Revised STAFF REPORT

PLANNING BOARD MEETING

August 10, 2016

Case # 25-16: SPECIAL PERMIT & SITE PLAN MODIFICATION
Riverside Landing Multi-Use Development at the
Former Fairhaven Mills
Riverside Landing/Coggeshall Street
Map 93, Lots 261 & 292
(a/k/a Map 93-2, Lots 264 & 261)

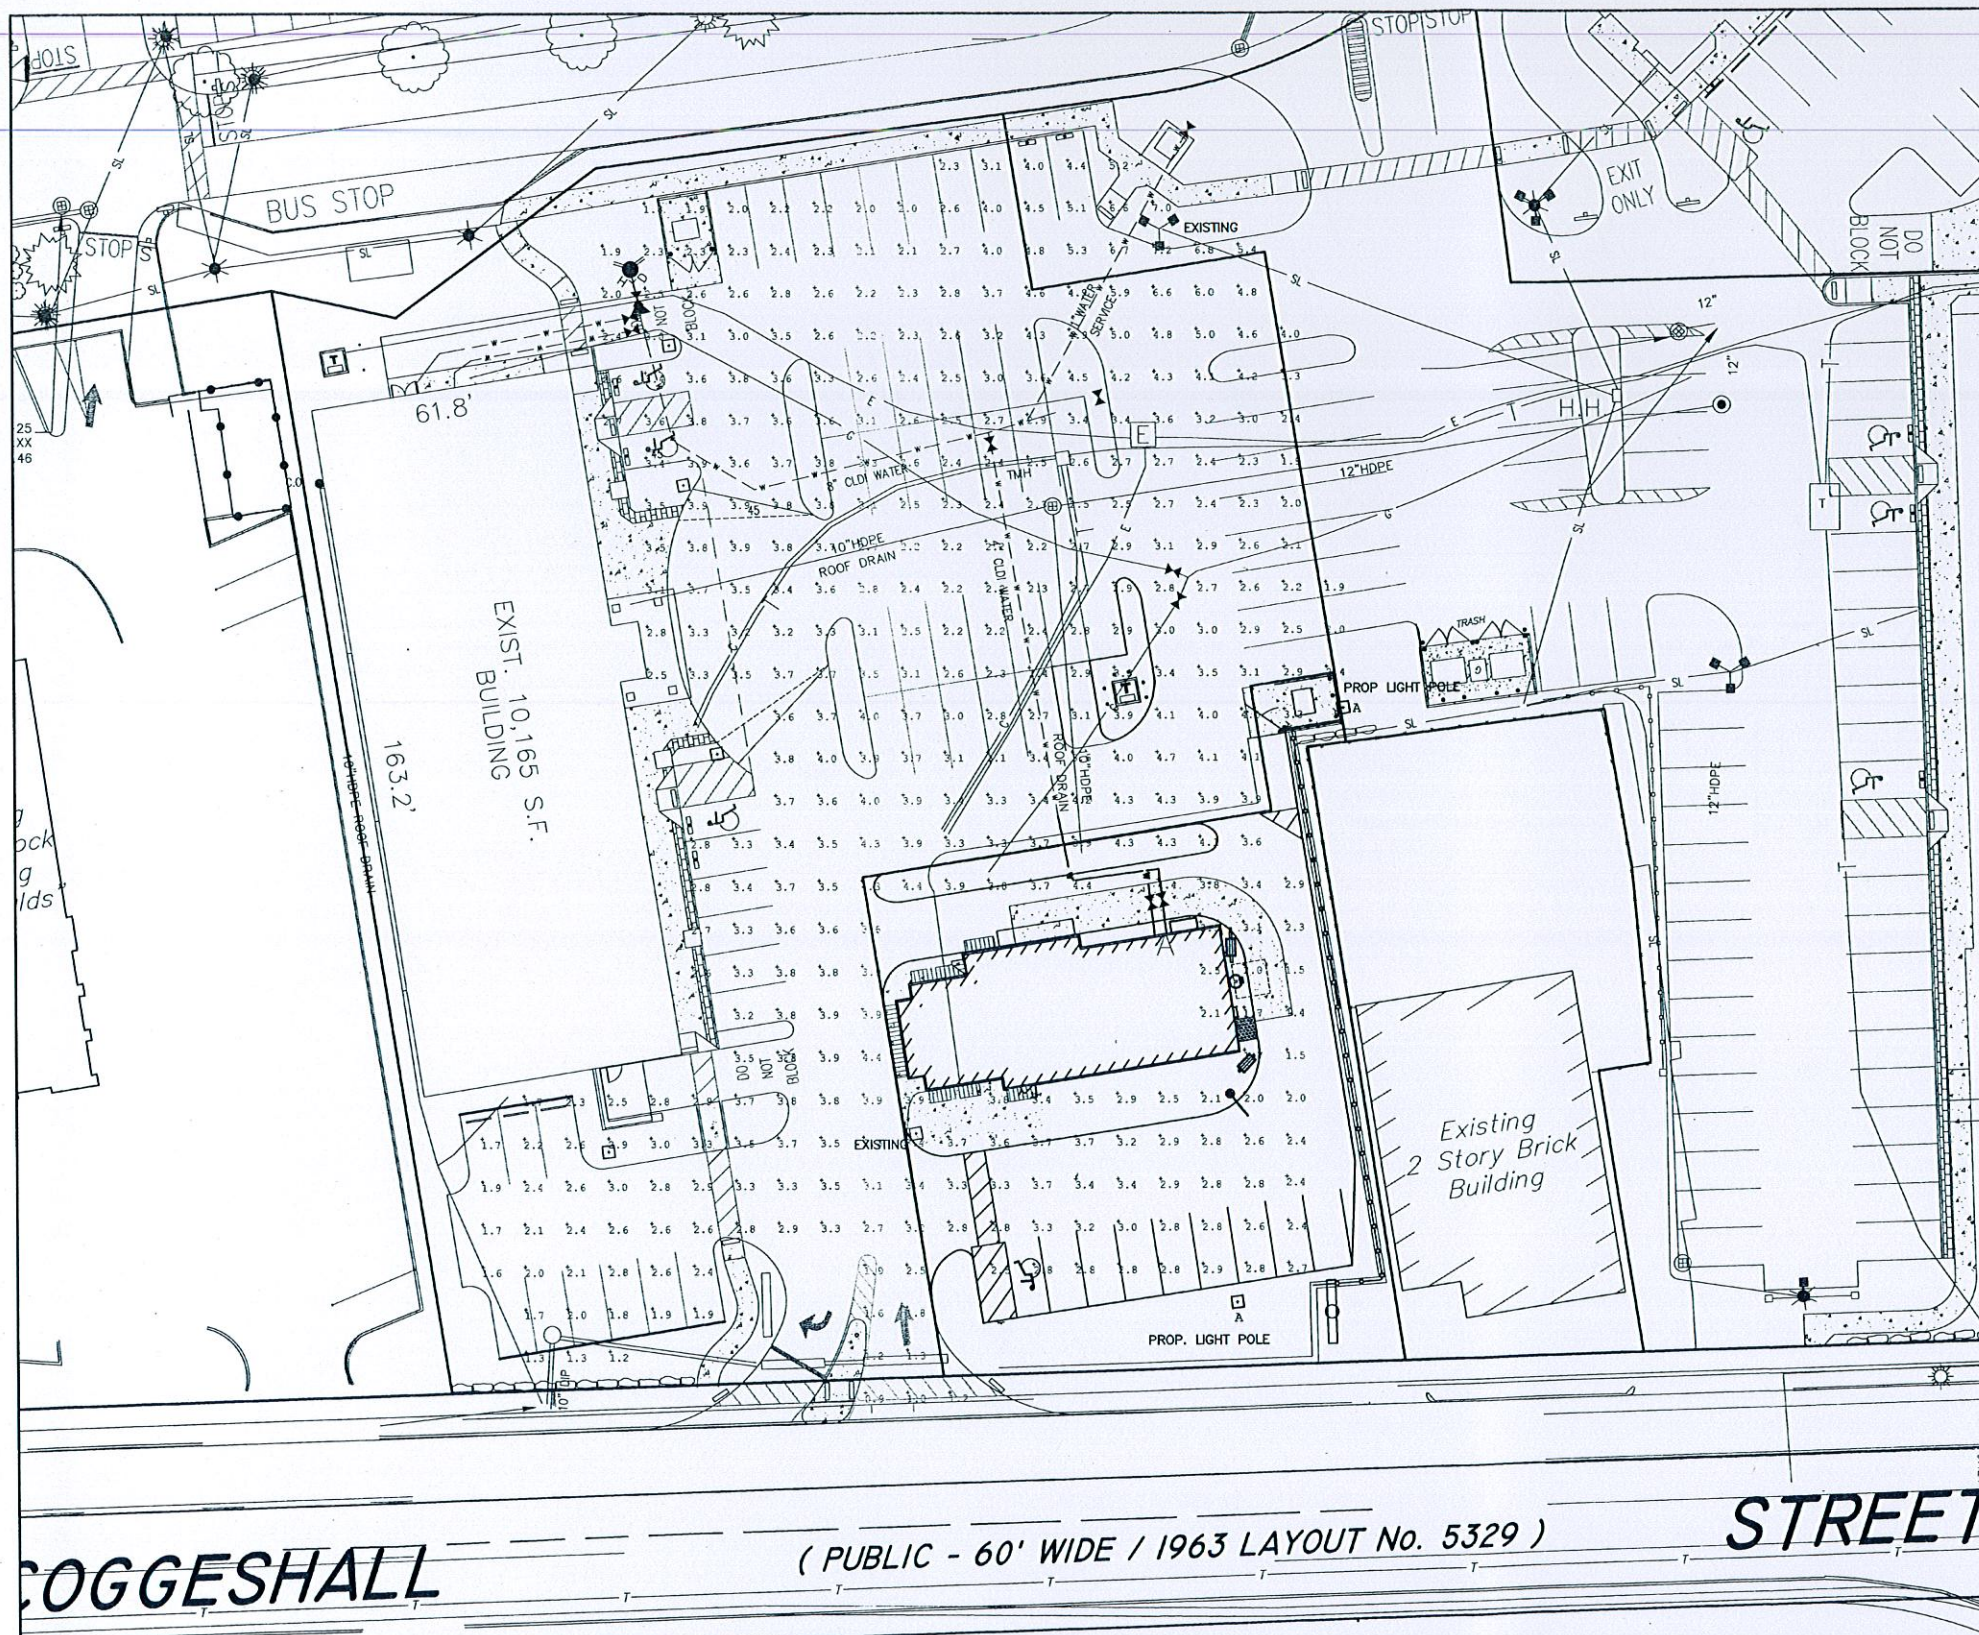
- **Lighting.** Lighting Plan sheet 6 notes, "Lighting to match lighting installed in previous phases of Riverside Landing". As a standard of practice, the approved plan should note that no substitutions, additions or

changes may be made without approval by the Planning Board or City Planner. Two light poles are shown on the Lighting Plan sheet. It appears that the area in proximity to the water kiosk illuminated at 6.8 foot-candles is slightly above the limitations recommended under Dark Sky guidelines of 5 foot-candles. No landscape lighting is shown on Landscape Plan sheet 7. Wall lighting is illustrated on elevation plans.

1 FLOOR PLAN
K-1 1/4"=1'-0"

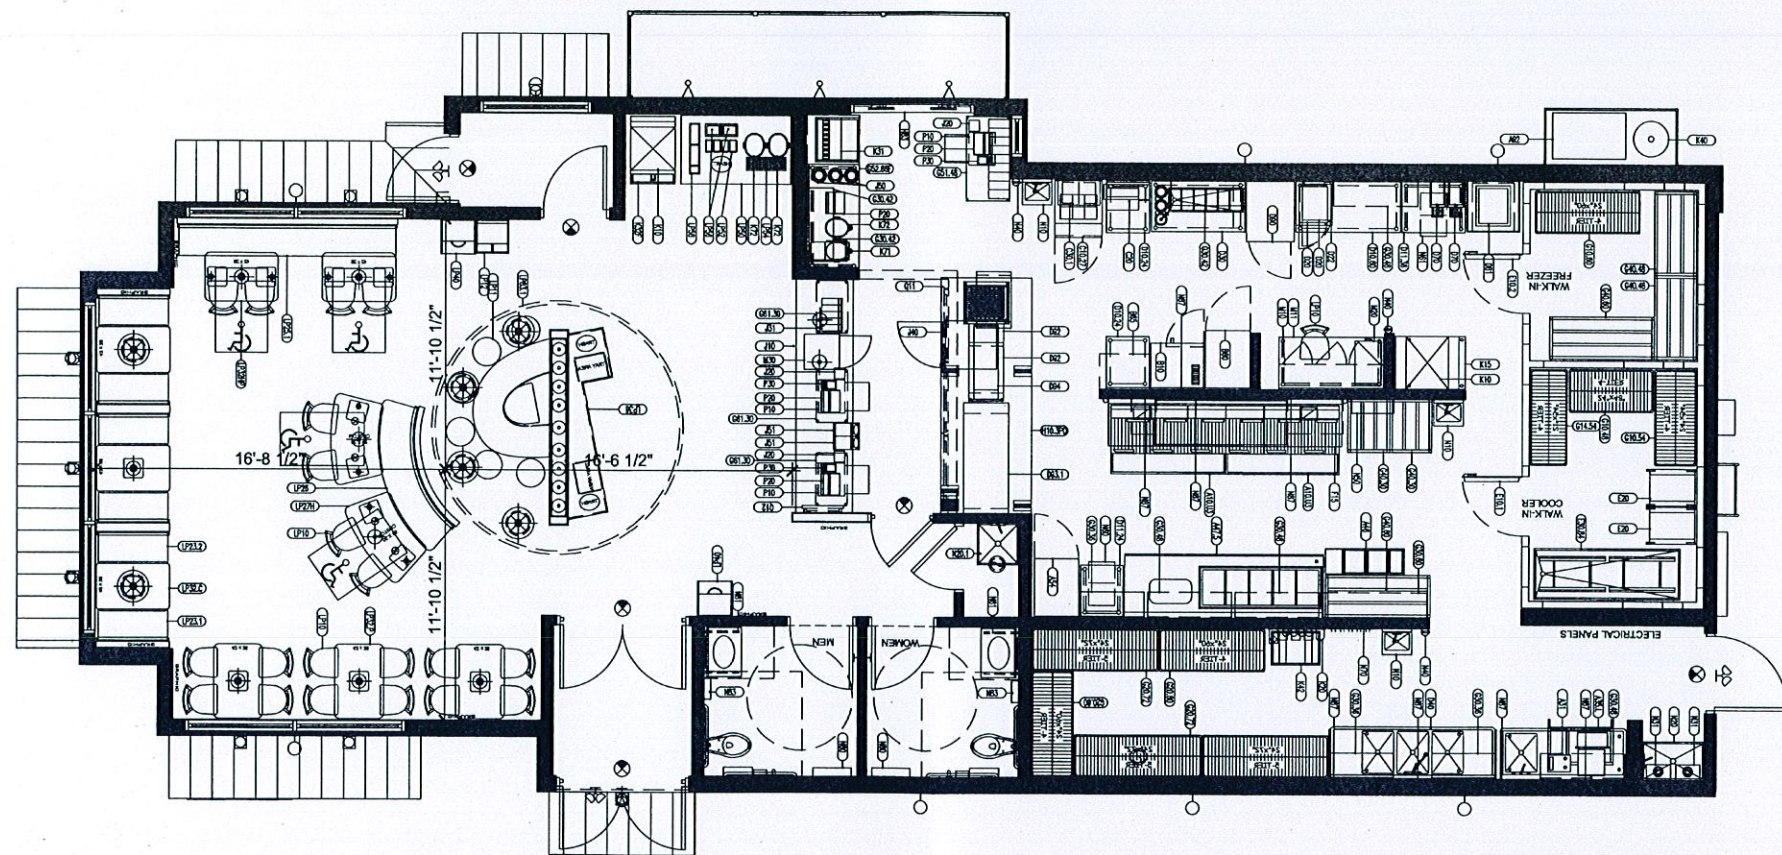
- The architectural plans have not been stamped or signed. The Board will want to ensure plans are prepared and signed by a registered architect as stipulated under §5440.
- The floor plan provided by the architect is a mirror plan of the building footprint shown on the proposed site plan. The discrepancy should be clarified, corrected, and shown in revised plan sets and drawings.

1. That the architectural plans be stamped or signed by an architect registered in the Commonwealth of Massachusetts as stipulated under § 5440.
2. That the frequency of deliveries to the business be clarified.

1 FRONT ELEVATION

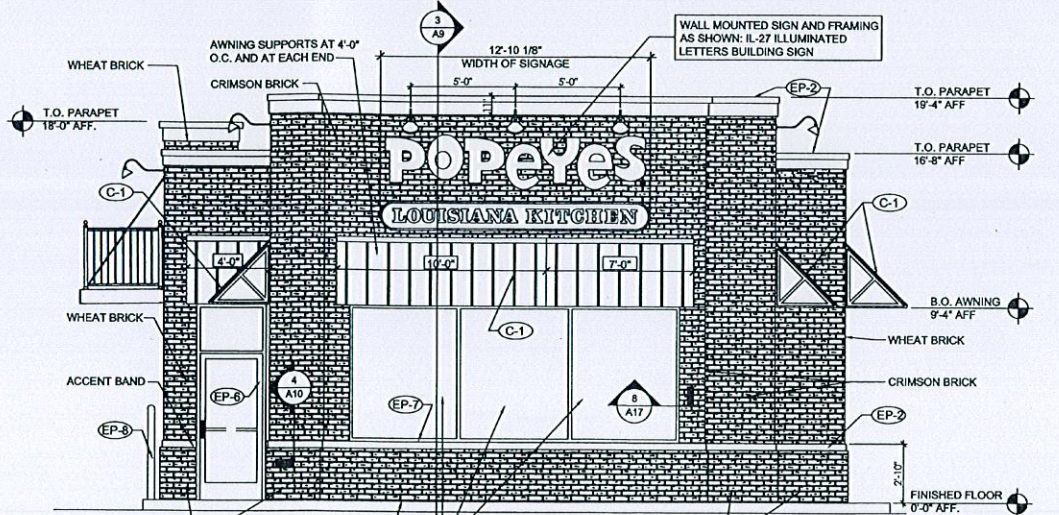
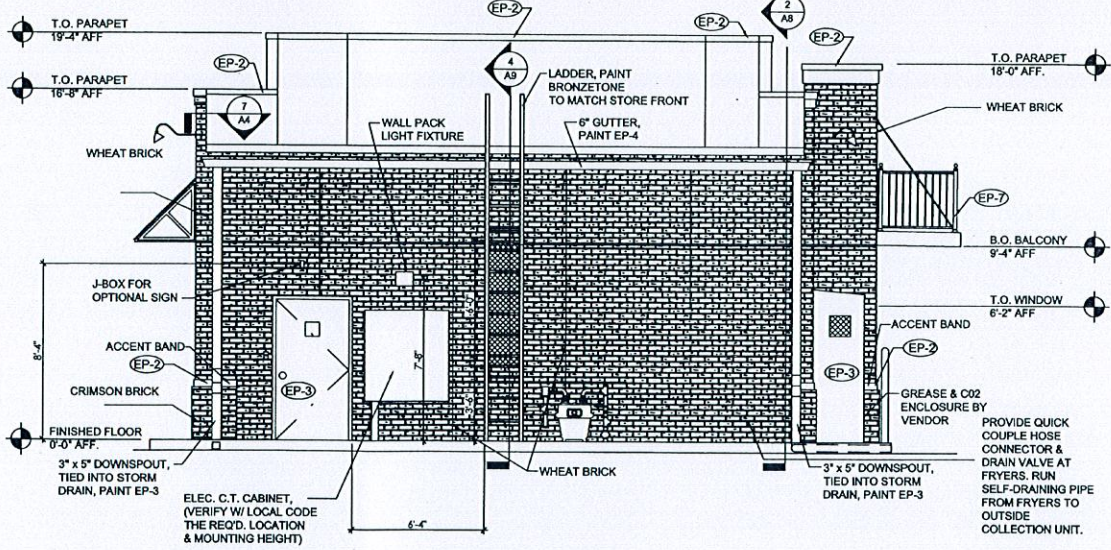
- **Roofing materials.** are specified as a UNA-CLAD Metal Roof system with installation described on Front and Rear Elevations plan sheet K-2. The Planning Board, as standard policy, looks for applicants to use cool roof or reflective roofing material in construction; this standard is also a principle of the IPOD. The Planning Board may desire to invite further comment from the applicant as to the energy efficiency of the metal roofing material specified for construction.

- The architectural plans have not been stamped or signed. Again; the Board will want to ensure plans are prepared and signed by a registered architect as stipulated under §5440.
